**South East Faversham (23/505553):
Transport and Highways Review**

client: Faversham Town Council

Railton TPC Ltd ref: Faversham 01B
Planning Inspectorate Ref: N/A
Planning Authority Ref: 23/505533
Date: July 2024
Author: Bruce Bamber BSc MA MSc MCIHT

Graph 2: AM Peak Trip Generation Rates (TRICS Database)

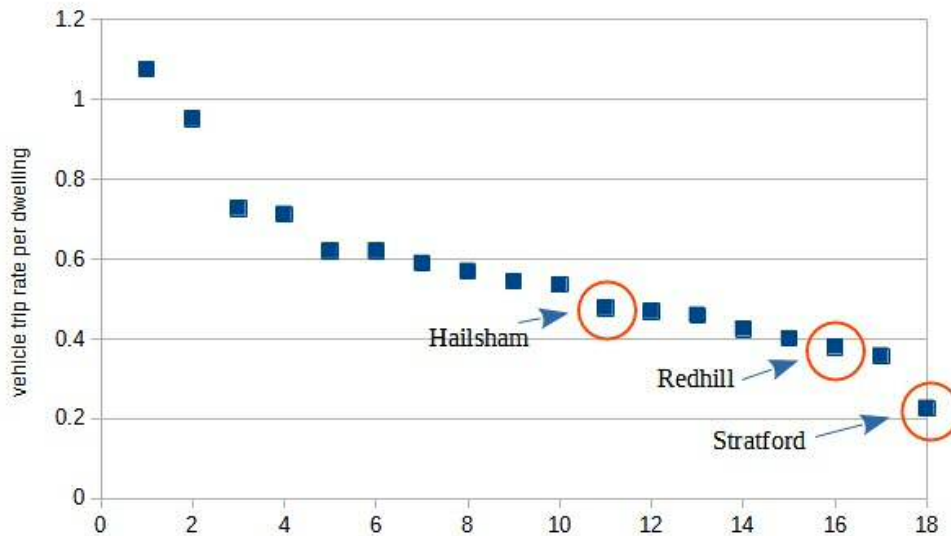
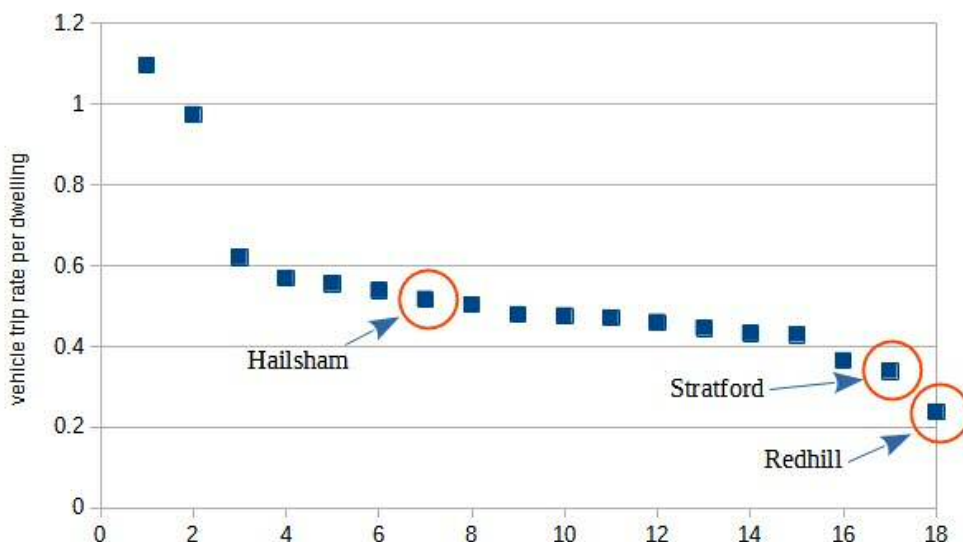
3.8 The Technical Note does not include a justification for selecting just these three sites from the TRICS database. The following graphs show the variation in vehicle trip generation rates at all the sites in the TRICS database that might have been used⁶. The sites are ranked from highest on the left to lowest on the right:

3.9 It is immediately apparent that the three sites that have been selected have some of the lowest peak hour trip generation rates of all those surveyed in the database. If ‘outliers’ with particularly high or low trip generation rates are excluded from the calculations it can be seen that typical peak hour trip generation rates are in the region of 0.5 vehicle trips per dwelling. The ‘business as usual’ (Scenario 1) trip generation rates cited in the TA are little over half of these rates. The label ‘business as usual’ is not appropriate since the rates are only slightly higher than the very lowest rates observed at other sites and bear no resemblance to average rates for similar sites.

Figure 32: Route 1 EB AM Min/Max Validation

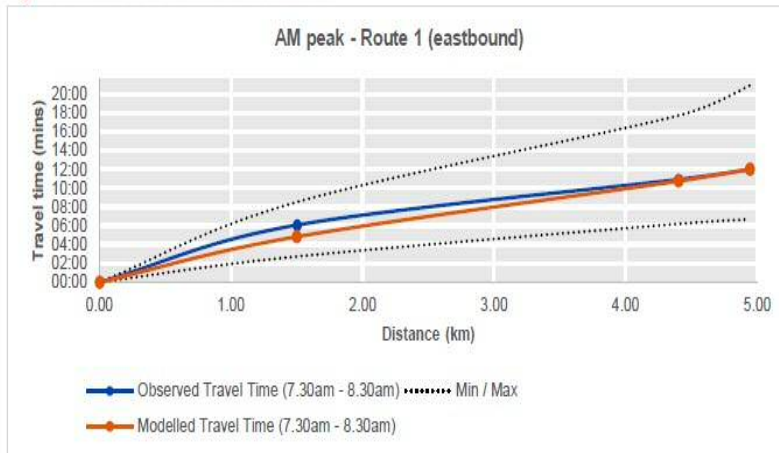
- 5.8 Appendix F of the VLMVR provides information about observed and modelled journey times. Graphs show the mean travel time and the minimum and maximum journey times observed. Although the mean observed journey times are generally close to the observed journey times, a much greater range between minimum and maximum observed journey times is indicated. For example, for Route 1 (A2 through Faversham) the following graphs are provided:

- 5.9 Whereas the mean observed eastbound (top graph) travel time is around 12 minutes at the end of the route (5km), the observed range is between just over 6 minutes and over 20 minutes. Guidance suggests that, *'End to end route times should be analysed, with the means and 95% confidence intervals of observed times being presented alongside the modelled times'* (TAG Unit M3.1 para. 9.3.1). No consideration has been given to 95% confidence intervals and no raw data showing observed journey times are included to allow 95% confidence intervals to be identified. **Further information is required to allow the reliability of journey time data to be checked.**

Figure 3: Step-Free Walking Routes

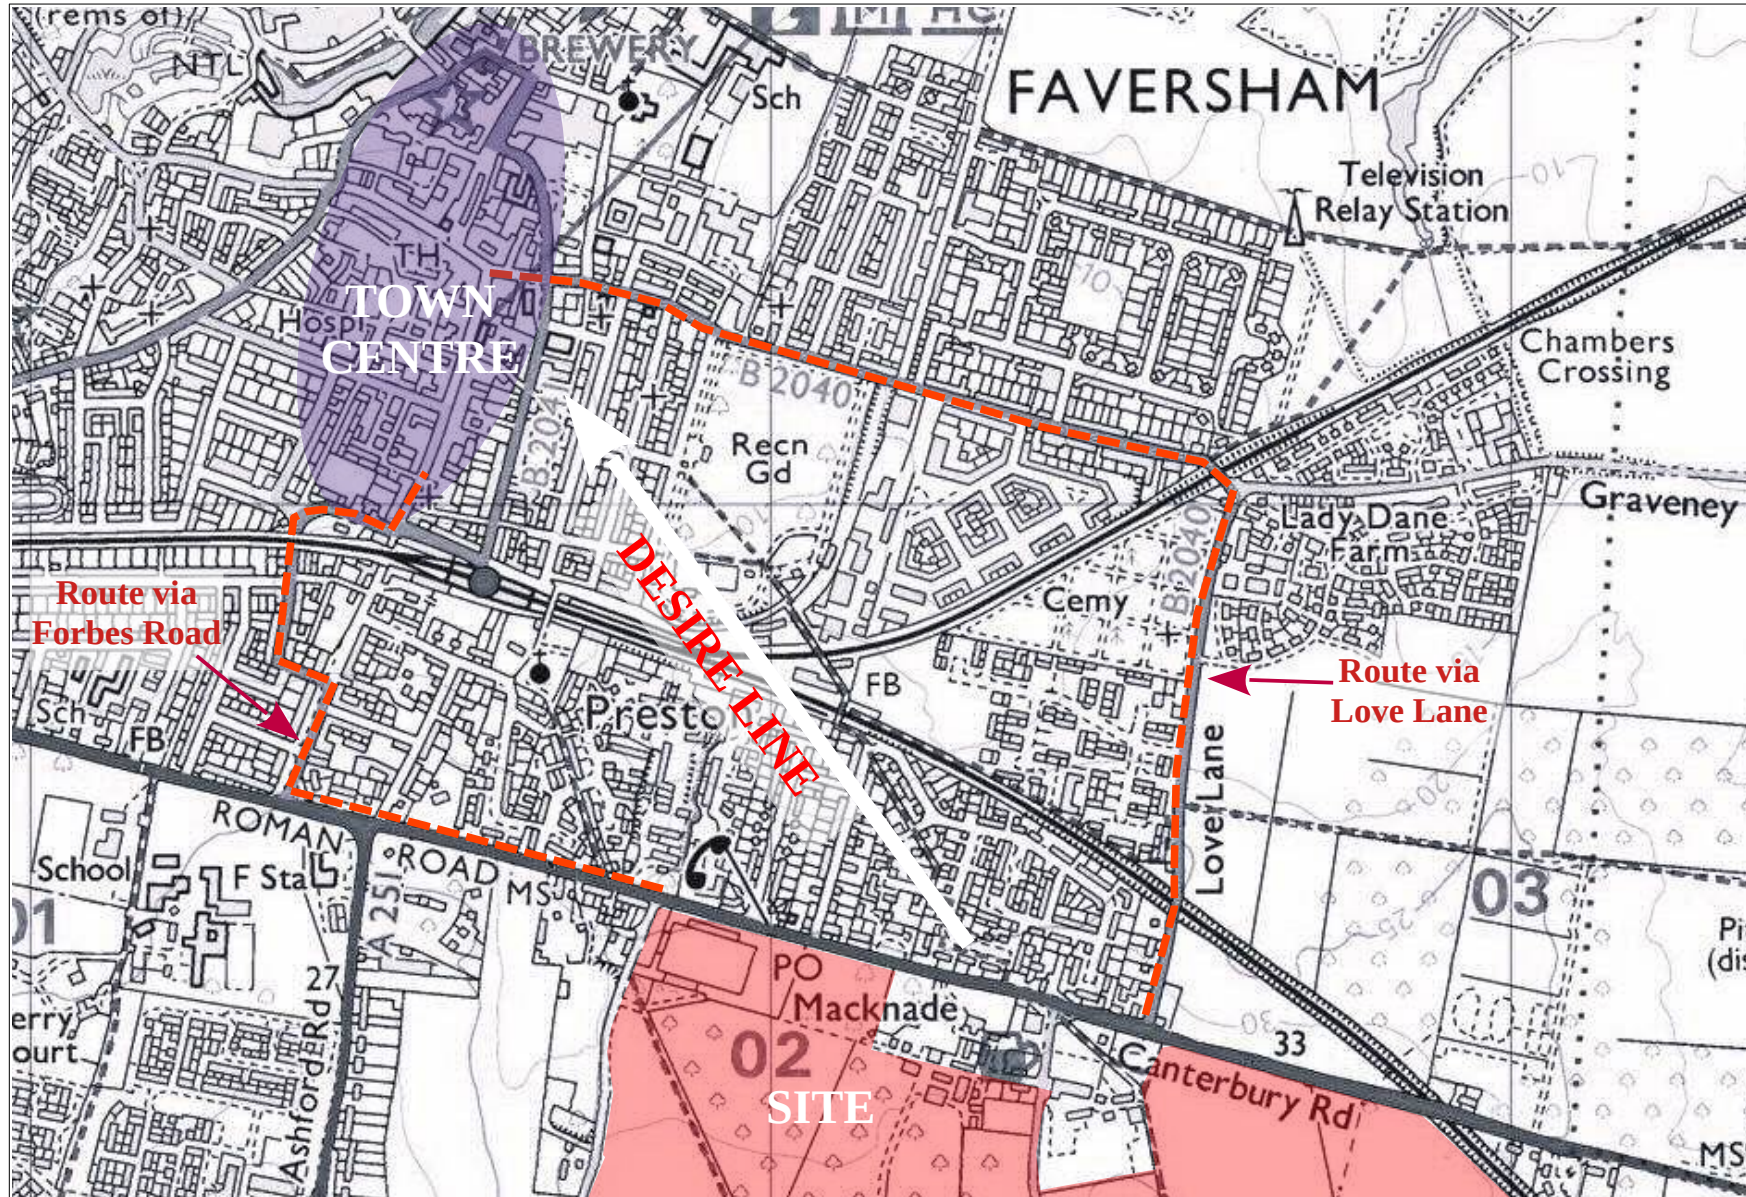
- 2.28 **Figure 3** shows the two shortest step free cycle routes between the site and the town centre. The LCWIP found the Love Lane route to be one of the two lowest scoring cycle routes, along with the A2 due to cyclists' exposure to general traffic. The Mall/Forbes Road route that passes under the railway has no cycle facilities and is subject to high vehicle flows and congestion during peak periods.

Figure 4: Proposed Cycle Facilities along A2

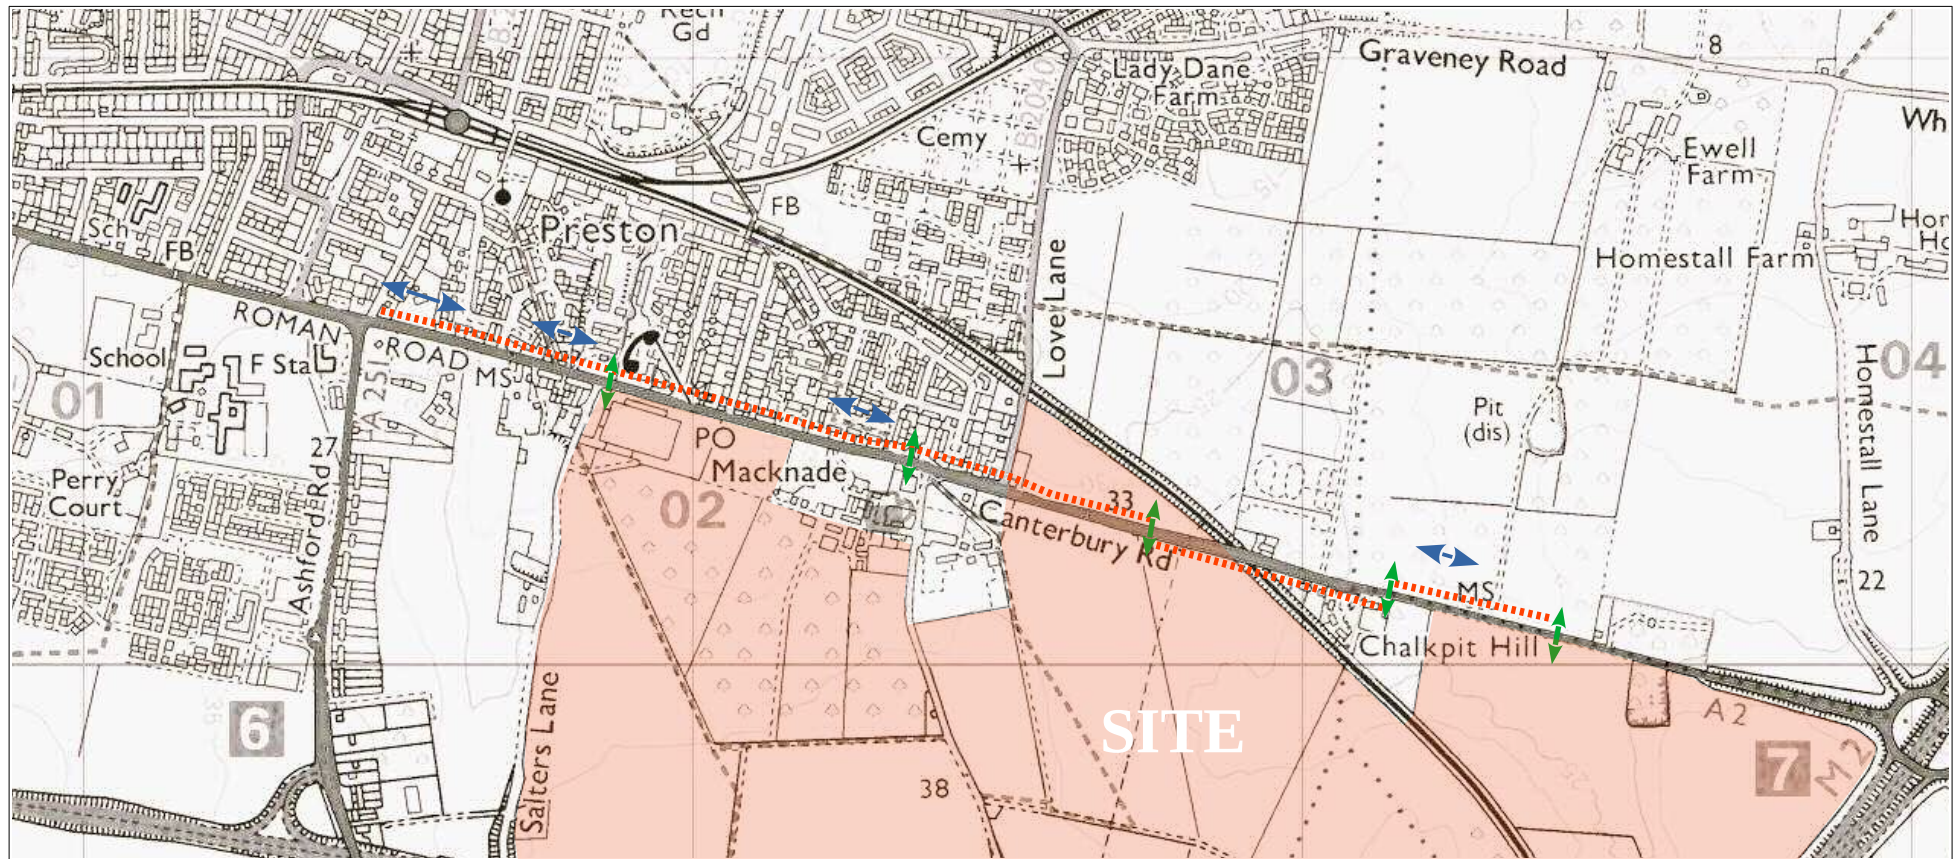
- 2.20 The minimum width of a shared use route is identified as 3.0m (see Table 6-3 of LTN 1/20). **Figure 4** shows three sections of the proposed footway/cycleway where the total width is less than 3.0m.

- 2.21 Where a cycle route is bounded by a fixed object (such as a wall or fence) that is over 600mm high, it is recommended that an additional 500mm (0.5m) width of cycle track is required to maintain the effective width of the cycle track (see Table 5-3 of LTN 1/20). It is clear that much of the proposed shared footway/cycleway through the existing built-up area of Faversham is bounded by high walls or fences. In these areas the effective width of the footway cycleway will be reduced by 0.5m.

- 2.22 There is also a constraint on the road side of the footway/cycleway. LTN 1/20 recommends an additional 200mm (0.2m) to avoid kerbs (see Table 5-3). In the case of the A2, it is likely that the footway/cycleway would need a buffer of more than 0.2m due to the volume and type of traffic using the A2. The proposal to reduce the width of the A2 to around 6.5m will mean that large vehicles will be forced to travel very close to the kerb, particularly when passing other large vehicles. A cyclist travelling close to the edge of the road would be in danger of colliding with the passing HGV or be at risk of losing control due to the violent displacement of air around the moving vehicle.

- 2.24 Even where the proposed shared footway/cycleway has a width of 3.0m, its effective width would be more like 2.0m due to solid barriers on one side and heavy traffic on the other. Where the proposed footway/cycleway is less than 3.0m, the effective width would be less than 2.0m.

- 2.26 It is concluded that the proposed shared footway/cycleway, over much of its length, particularly through the existing built-up area of Faversham falls well short of standards and is likely to be unacceptable for highway safety reasons.

corner via internal cycle routes, would be forced to travel around 400m further west along the A2 before reaching Preston Grove, the first opportunity to leave the A2 and travel towards the town centre to cross the railway at Forbes Road. It is this section of the proposed shared footway/cycleway along the A2 that is most constrained in terms of width and edge constraints (see **Figure 4**).
